Access Compliance Report Public Rights-of-Way (Island Curb Cuts)

Main Street: SIENNA_PKWY		Cross Street: SIENNA_PKWY		Location:	E
ADA ID: CCRK211104121935	Curb Cut Type: MedianRefuge2	Initial Pass/Fail: Pass	Overall Compliance: No	Severity Score:	15
Codes/Mitigation Info/Possible Solution			Field Measurements/Component Compliance

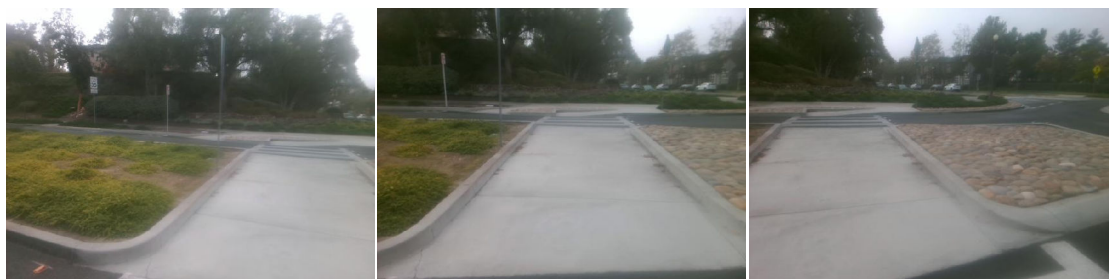
Possible Solutions:

Install Detectable Warning System.
